SUBJECT: ECCS PERFORMANCE SAFETY ASSESSMENT AND AUDIT REPORT

ECCS Performance Safety Assessment

Audit Report for PWROG and BWROG ECCS Performance Margin Assessment

Figure 2-2: Allowable CP-ECR versus Pellet Exposure

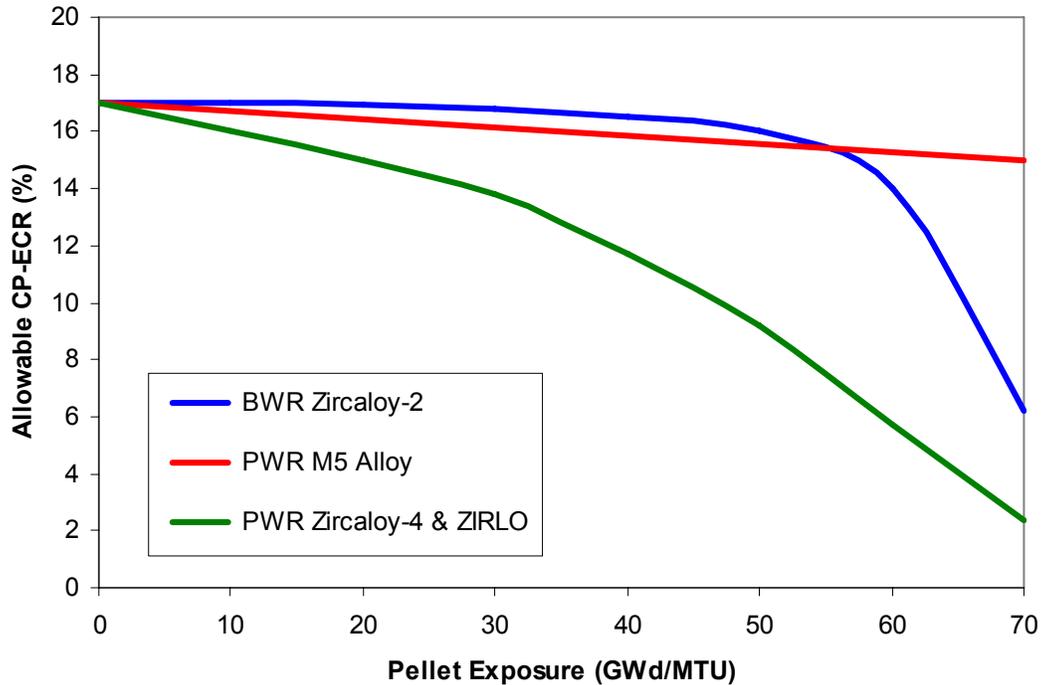
Figure 2-2 illustrates that allowable Cathcart Pawel (CP)-ECR as a function of peak pellet exposure used in the BWROG and PWROG assessments.

Question #8 of the audit plan requested further information on the assumed hydrogen content (and associated allowable CP-ECR) for Group 7. Westinghouse stated that the CE plants comprising Group 7 used conservative Appendix K evaluation models and would have difficulty showing compliance to the bounding ZIRLO analytical limits. As such, new ZIRLO analytical limits were developed using plant-specific fuel duty calculations and the new Westinghouse ZIRLO corrosion model currently under staff review (WCAP-12610-P-A & CENPD-404-P-A, Addendum 2). A hydrogen pickup fraction of 15% was used to convert calculated oxide thickness to cladding hydrogen content (and allowable CP-ECR). This pickup fraction is conservative relative to the 12.5% developed for FRAPCON-3. As a result of these calculations, the Group 7 plants were assessed against a cladding hydrogen content of 267 ppm with an allowable CP-ECR of 10.0%. As stated above, the use of a best-estimate corrosion prediction and hydrogen content is acceptable for this evaluation. However, the staff may require an approved, upper-bound model for future compliance demonstration.

Figure 2-3: BWR/2 LOCA Calculations at COLR TMOL
(Source: Figure 5 of BWROG-TP-11-010)

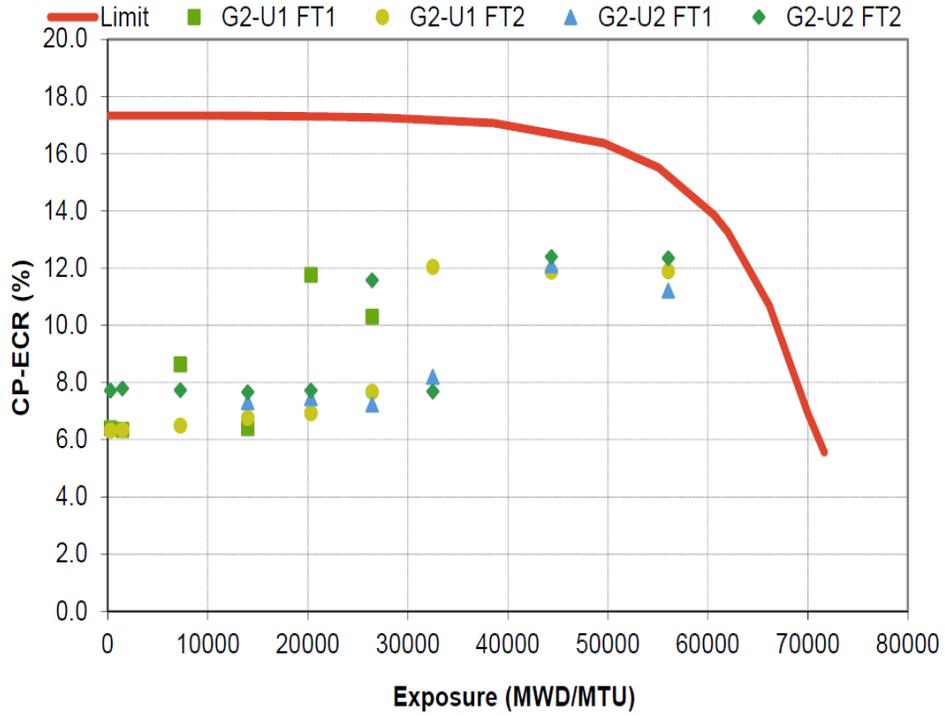
Using currently approved SAFER/CORCL models, GEH performed new LOCA analyses crediting the existing COLR thermal-mechanical operating limits (TMOL) for several lattice types in both GE11 and GNF2 fuel bundle designs. For the BWR/2 design, COLR maximum average planar linear heat generating rate (MAPLHGR) limits are dictated by calculated PCT early in life and by calculated ECR at higher exposure levels. However, fuel rod power levels may be further restricted because of fuel rod thermal-mechanical design criteria (e.g., rod internal pressure, power-to-melt). Figure 5 of BWROG-TP-11-010 (shown as Figure 2-3 below) illustrates the calculated CP-ECR for both BWR/2 plants and fuel designs. As part of the audit, the staff reviewed GEH calculation DRF 0000-0132-1436, Revision 0. It should be noted that GEH applied a conservative correction factor to the calculated CP-ECR to account for any cladding ID oxygen ingress prior to the time of rod burst. These results demonstrate that the calculated CP-ECR remains below the revised Zry-2 PQD analytical limit at all exposures when the more restrictive TMOL rod power limits are credited.

GEH recently discovered several errors in their LOCA evaluation models. The impact of these errors have been documented in 10 CFR 50.46(a)(3) reports. These errors were corrected in the new BWR/2 LOCA analyses done in support of this margin assessment. Due to the existing margins in BWR/4, /5, and /6 plants, no new LOCA calculations were performed. The impact of these errors is expected to be minimal for these plants and would not change the conclusions of this margin assessment.

Figure 2-4: BWR/3 LOCA Calculations at COLR TMOL
(Source: Figure 1 of Westinghouse Proprietary Calculation CN-LAM-11-23)

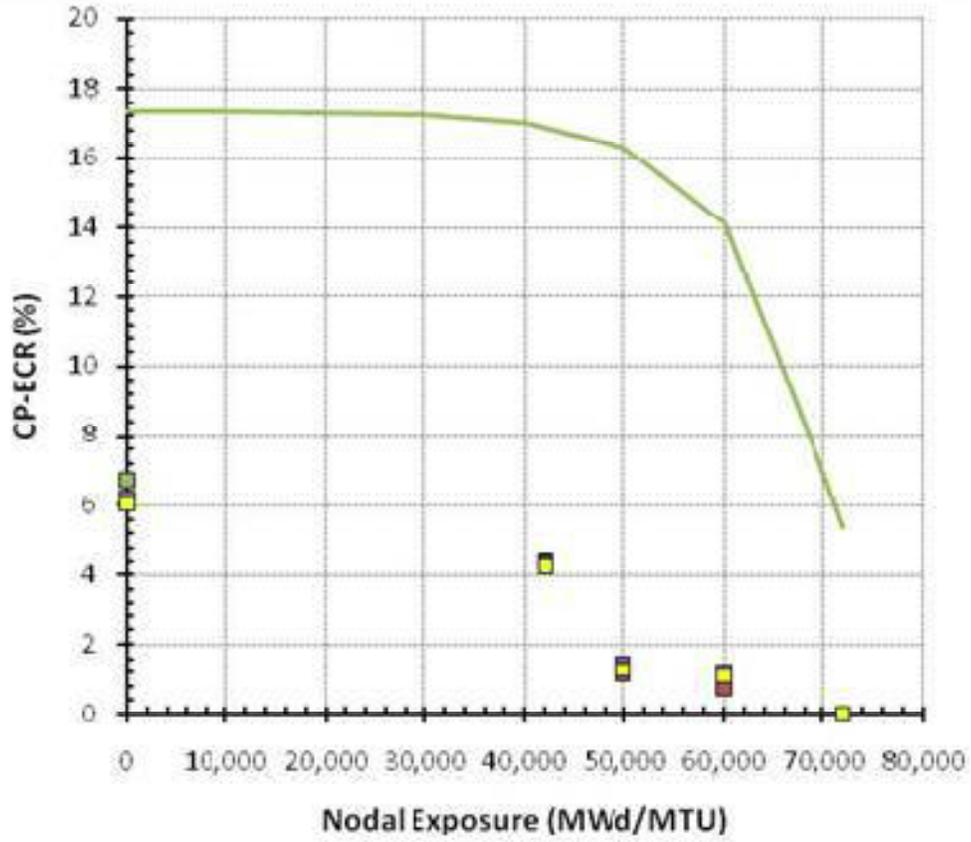
Similarly, Westinghouse performed new LOCA analyses crediting the existing COLR thermal-mechanical operating limits for their 4 BWR/3 plants. As with the BWR/2 plants, the allowable fuel rod power level for BWR/3 plants is governed by fuel rod thermal-mechanical design criteria at higher exposure levels. Question #12 of the audit plan requested further information on intermediate power cases. As discussed during the audit and documented in Westinghouse calculation CN-LAM-11-16, Westinghouse provided the results from LOCA calculations at 40, 50, 60, and 70 GWd/MTU (nodal exposure). These results (shown below in Figure 2-4) demonstrate that the calculated CP-ECR remains well below the revised PQD analytical limit at all exposures when the more restrictive TMOL rod power limits are credited.

No new LOCA calculations were included for the remaining 2 BWR/3 plants fueled with GEH fuel designs. The GEH BWR/2 calculations and Westinghouse BWR/3 calculations clearly demonstrate that the TMOL rod power envelope limits transient oxidation to within the new analytical limits at high exposure. This conclusion is equally valid for the remaining 2 BWR/3 plants. During the audit, GEH stated that preliminary BWR/3 calculations were performed and validated this margin; however were never documented.

Figure 2-5: Typical BWR COLR Thermal-Mechanical Operating Limits
(Based on ADAMS ML110940268)

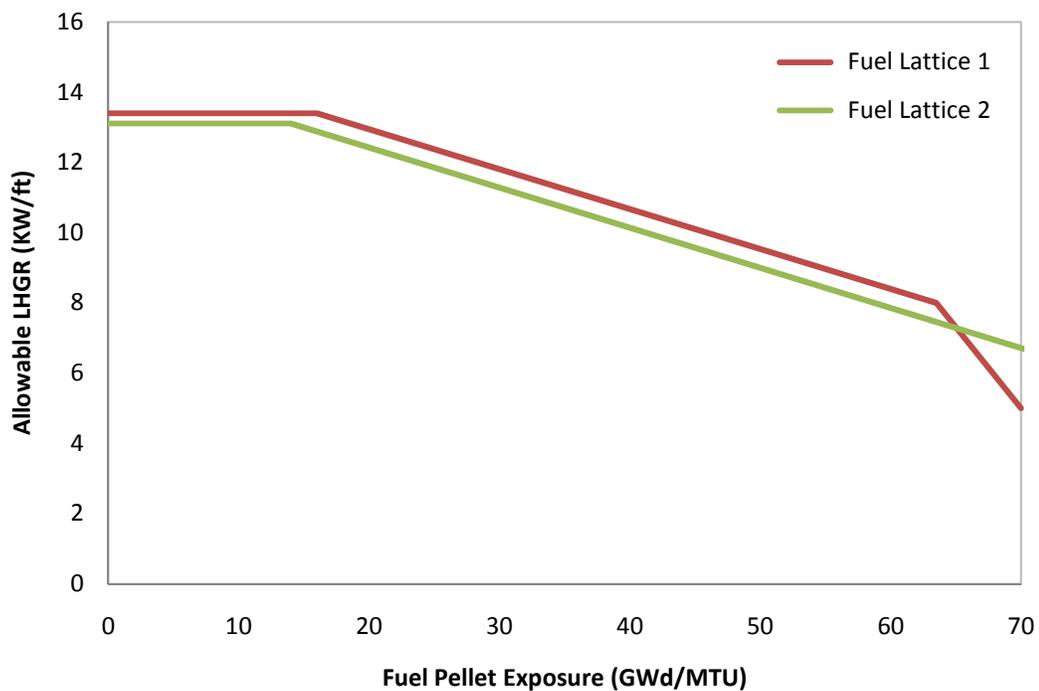
COLR TMOL rod power envelopes are continuously monitored by the plant computer. In general, TMOL rod power envelopes are developed for each fuel lattice configuration and are

not expected to change on a cycle-specific basis (although their inclusion in the COLR would allow frequent changes). Figure 2-5 illustrates the decrease in allowable peak nodal power with exposure for a typical COLR TMOL.

Figure 2-6: Group 5 Burnup Study
(Source: Westinghouse Audit)

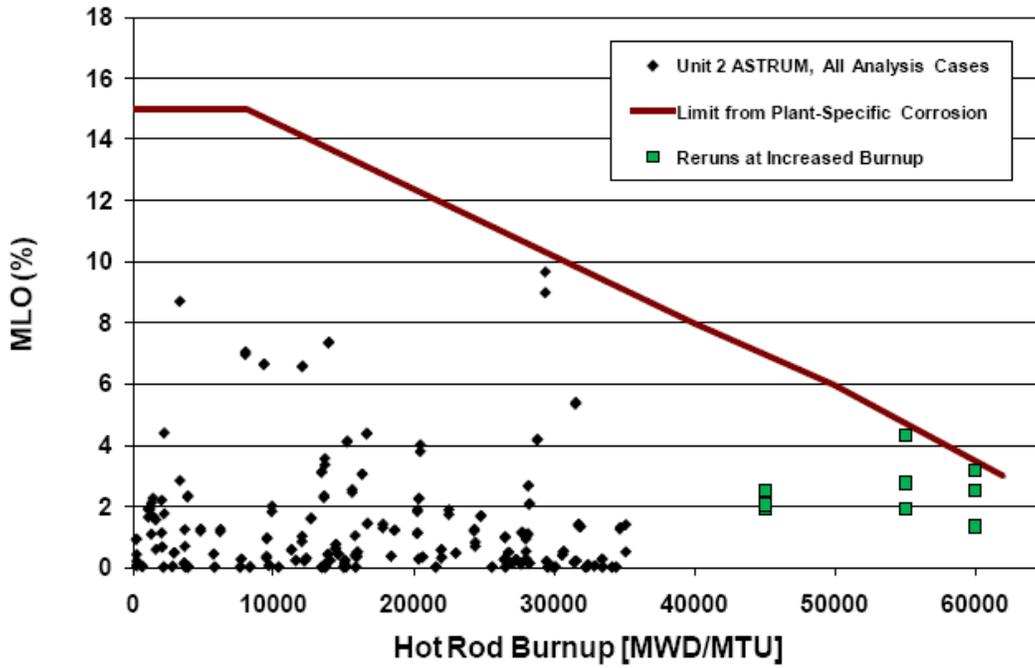
The "Burnup Study" credit in Section 5.6 of PWROG Report OG-11-143 is based on explicit LOCA calculations performed to evaluate IN 98-29. Only 1 Westinghouse plant comprises Group 5 and utilizes this credit (See Table 5 of PWROG Report OG-11-143). Question #7 of the audit plan requested further information on this burnup study. During the audit, Westinghouse provided results of LOCA calculations performed at several higher exposure points for the most limiting cases from the ASTRUM analysis. For this evaluation, there was no credit taken for a reduction in peaking factors at the increased burnup steps. Figure 2-6 illustrates the results of this evaluation. Examination of this figure reveals that the analysis-of-record (AOR) MLO at low and intermediate exposure (shown as black diamonds) as well as the high exposure cases (shown as green squares) remain below the revised analytical limit. Note that 4.3% ECR which is reported in the PWROG report for Group 5 corresponds to the highest ECR result from the cases run at increased burnup.

It is reasonable to credit lower fuel rod power at higher exposure where fuel rod thermal mechanical design restrictions are more limiting than LOCA restrictions. However, without a specific COLR reference (e.g., BWR TMOL), it is questionable whether the licensee complies with 10 CFR 50.36(c) which requires limiting conditions for operation important to safety be captured in technical specifications. For future compliance demonstration, the staff may require that PWR plants update their COLR and include any exposure dependent rod power limitations important to safety (either thermal-mechanical design or LOCA).

Figure 2-7: SBLOCA Calculations with ANS-1979 +2 σ Decay Heat
(Source: Westinghouse Proprietary Calculation CN-LIS-11-8)

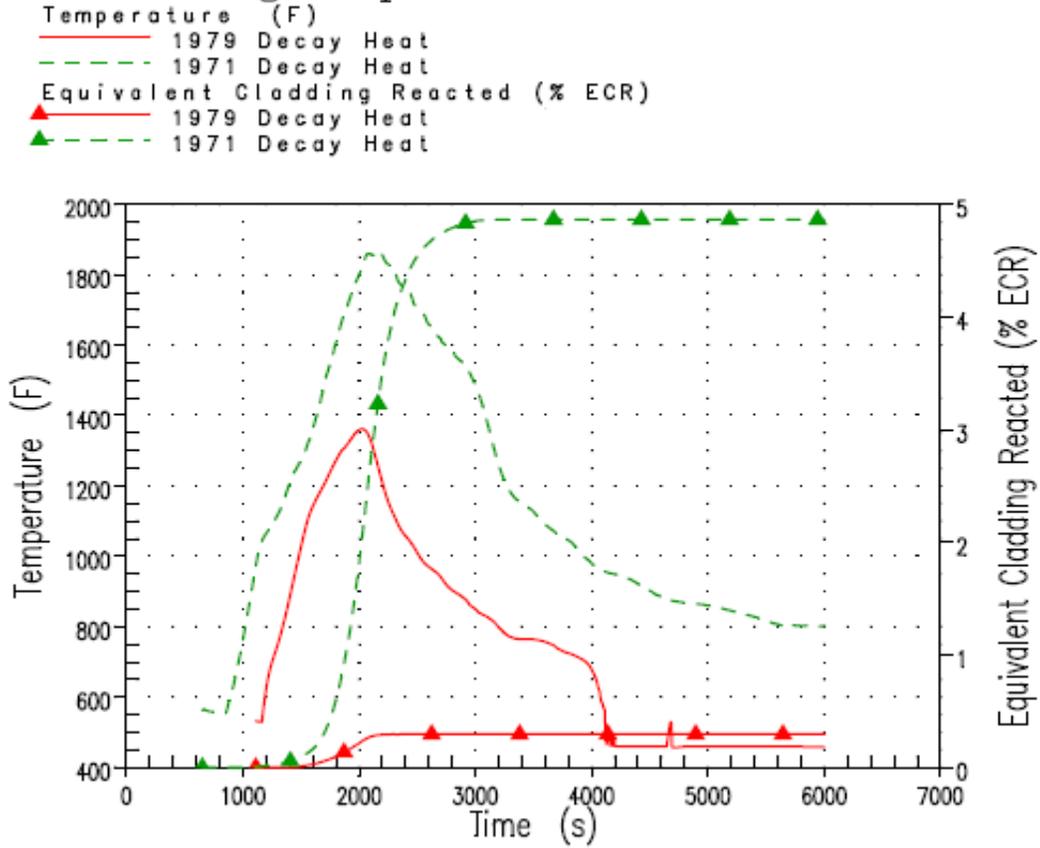
Appendix K requires the use of ANS-1971 decay heat model plus 20% uncertainty. For realistic ECCS evaluation models, the staff has accepted the use of the ANS-1979 decay heat model plus 2σ uncertainty. However, no realistic models have been approved for SBLOCA. SBLOCA Group 2, consisting of 5 PWR plants, takes credit for this adjustment. Question #10 of the audit plan requested further information on the applicability of this credit to the 5 plants in SBLOCA Group 2. Westinghouse calculation CN-LIS-11-8 documents explicit SBLOCA calculations using the ANS-1979 plus 2σ decay heat model. NOTRUMP results show that by assuming a lower decay heat, less heat is generated in the core while it is uncovered. Less heat generation allows for additional system depressurization. Lower system pressure results in more injected flow both from the ECCS pumps and the accumulators. Therefore, the core exit vapor temperature is significantly reduced. As shown in Figure 2-7, the core uncovers for a shorter period of time and the resulting calculated PCT and local oxidation are significantly lower.

Figure 2-8: SBLOCA Group 2 Limiting Plant AOR Results
(Source: Westinghouse Proprietary Calculation CN-LIS-11-8)

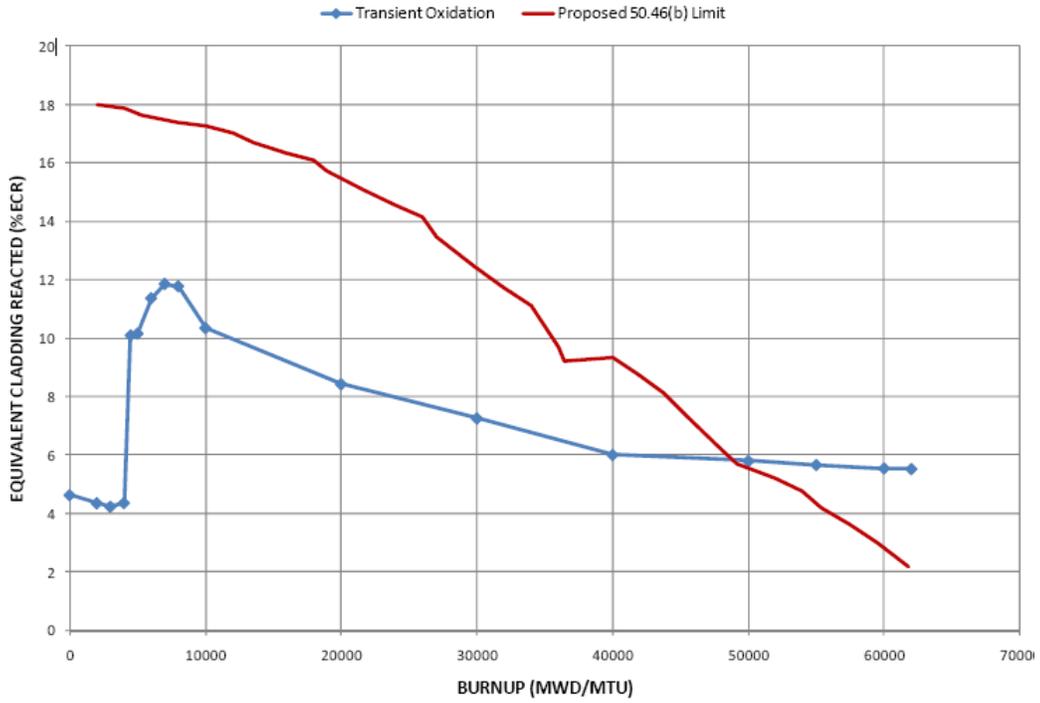
The AOR results, shown in Figure 2-8, illustrate that the calculated MLO exceeds the proposed ECR analytical limits at high exposure. Table 2-1 lists the calculated results for this limiting plant. Examination of this table reveals the significant benefit from switching to the ANS-1979 decay heat plus 2σ uncertainty on calculated results. In addition to calculations performed for the limiting PCT plant, a separate evaluation was completed for the limiting MLO plant in Group 2. This evaluation confirms the applicability of the calculated credit.

Figure 2-9: PQD Measurements from EPRI-Sponsored Research
(Zircaloy-4 Oxidized at 1922 °F)

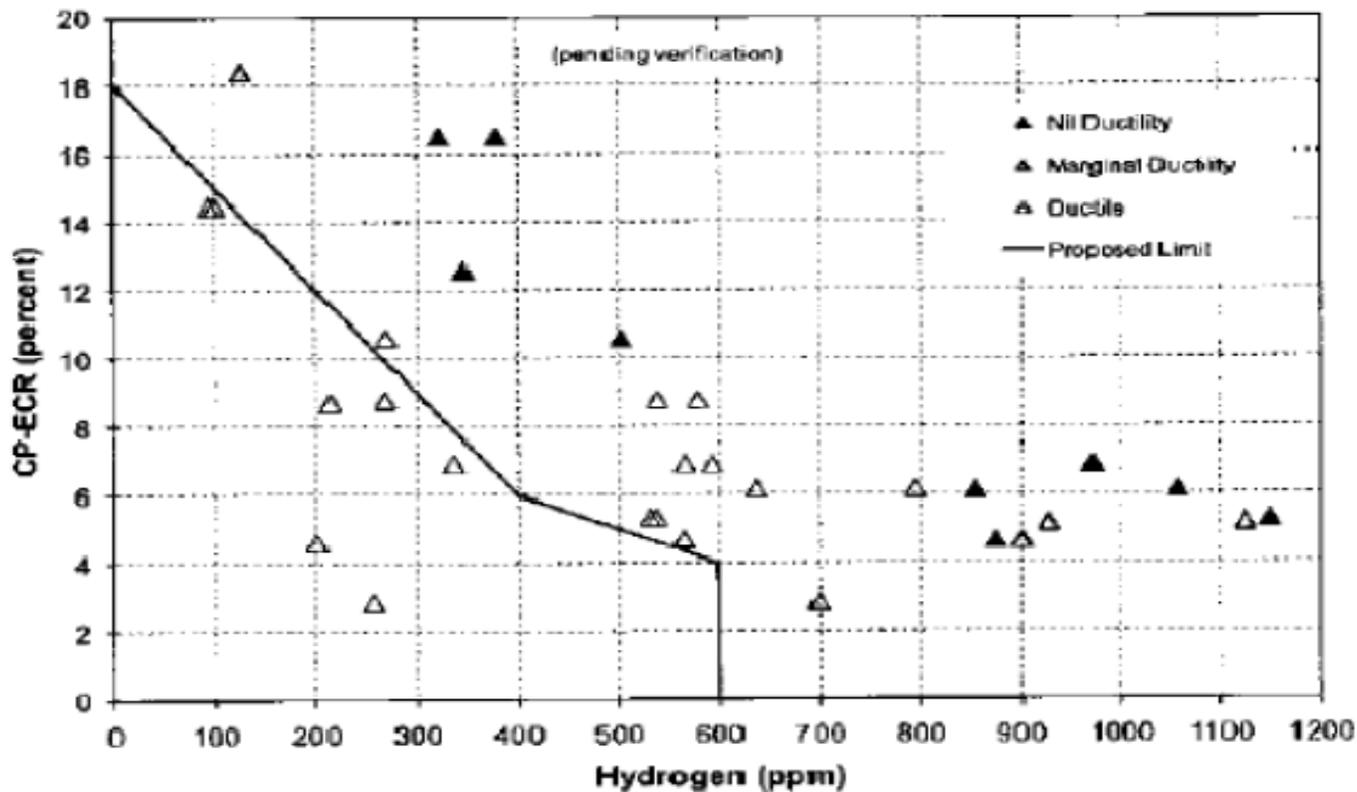
The empirical database used to develop the PQD analytical limits in DG-1263 is comprised mostly of ring-compression tests performed on cladding segment exposed to steam oxidation at 2200 °F. Results from EPRI-sponsored research conclude that testing conducted at a maximum temperature below 2200 °F yield a higher allowable CP-ECR at the ductile to brittle transition. This finding is consistent with results from earlier research. The 7 PWR plants in Group 6 credit an increase in allowable CP-ECR of 2.5% (5.7% to 8.2%) based on the results of the EPRI-sponsored research. Figure 2-9 plots the results of this research. Examination of the data suggests that the 2.5% increase in allowable CP-ECR is supported by the testing. This conclusion hinges on the PCT for high burnup fuel remaining below 1922 °F. The maximum PCT reported for the Group 6 plants is 2028 °F. This calculated PCT represent the highest power, low burnup fuel rod. Results from the reload power history calculations above illustrate the likely reduction in PCT for higher burnup fuel rods. Hence, it is reasonable to conclude that fuel rods at 50 GWd/MTU would have a calculated PCT less than 1922 °F for these plants.
